Memorandum Department of Planning & Development Services

RE: Forty West Office Building, Sign Package: A request for a Sign Package

Planning Commission Staff Report

Project Type: Sign Package

Figure 4: Existing and Proposed Monument Sign Conditions

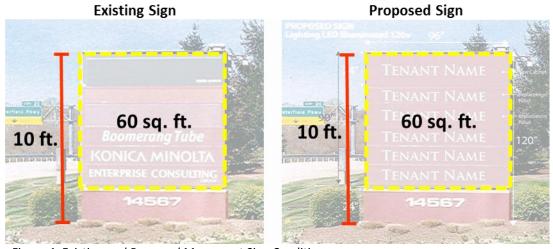
Sign A - Freestanding Monument Sign — This sign is located along the property's frontage of North Outer 40 Road and currently serves the office tenants located within this development. These tenants are served by a common entrance, and the UDC only permits individual signage for tenant spaces that have independent entrances. The applicant is proposing to remove the top electronic message portion of the existing sign and replace this portion with an aluminum cabinet consistent with the size and style of the existing panels identifying individual tenants. The applicant is also proposing to replace the existing panels to provide a more cohesive look among the tenant names. The existing size of the monument sign will remain unchanged with an overall height of ten (10) feet and sign face outline area of 60 square feet. The existing sign is not currently illuminated and the applicant is proposing to install internal low voltage LED lighting. The existing and proposed conditions of the monument sign are depicted in Figure 4 below.

Modifications to the existing monument sign include removal of the electronic message center on the top portion of the sign and replace with a sign panel to serve as tenant identification to match the remainder of the sign. The applicant has also indicated in the narrative statement submitted that all panels on the sign cabinet will be replaced in order to establish a cohesive style among the tenant identification, and internal LED illumination will be added as none currently exist.

The site specific ordinance for this development permits one (1) monument sign not to exceed ten (10) feet in height and 75 square feet in outline area to be landscaped around its base. The overall size of the sign will remain unchanged and existing landscaping will be maintained in accordance with this regulation. Table 1 to the right details the permitted and proposed elements for a monument sign at this location.

Figure 5: Overview of Sign Package Requests

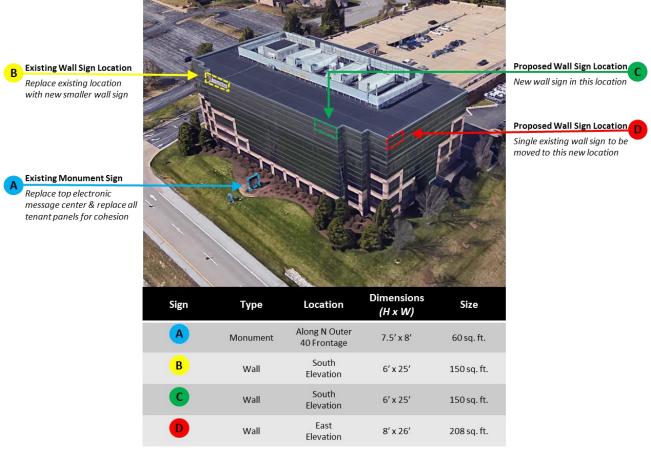
<u>Sign B - Attached Wall Sign (West Corner of South Elevation)</u> – This attached wall sign location is on the western end of the south elevation facing North Outer 40 Road and I-64/US-40. Currently, this location has the only attached wall sign permitted for this development, which is 208 square feet in outline area. This existing sign is proposed to be relocated to the east elevation (Sign "D") and replaced with a 150 square foot attached wall sign in its place.

<u>Sign C - Attached Wall Sign (East Corner of South Elevation)</u> – This attached wall sign location is opposite Sign "B" on the eastern end of the south elevation of the building. There are no current signs in this location, and a 150 square foot attached wall sign is proposed for this location to match the size and dimensional regulations proposed for "Sign B" noted above.

Sign D - Attached Wall Sign (South Corner of East Elevation) – This attached wall sign location is on the southern end of the east elevation of the building and is also visible from North Outer 40 Road and I-64/US-40 though there is no roadway frontage. The existing sign on the south elevation is proposed to relocate to this location and has a total of 208 square feet.

The size of the attached wall signs permitted on roadway frontage utilizing the five percent (5%) measurement exceed the 300 square foot maximum limit on both the south and north elevation. Each sign shall not be larger than 300 square feet, producing a total of 600 square feet of wall signage permitted on the building. The request is for a total of 508 square feet of wall signage to be

dispersed among the south and east elevations; 300 square feet of which is proposed to be equally divided for two wall signs on the south elevation, and the remaining 208 square feet is proposed for the east elevation as a relocation of the existing wall sign. Table 2 above details the permitted and proposed elements for wall signs at this location.

• Limit the sign for the eastern façade to no more than 150 square feet.
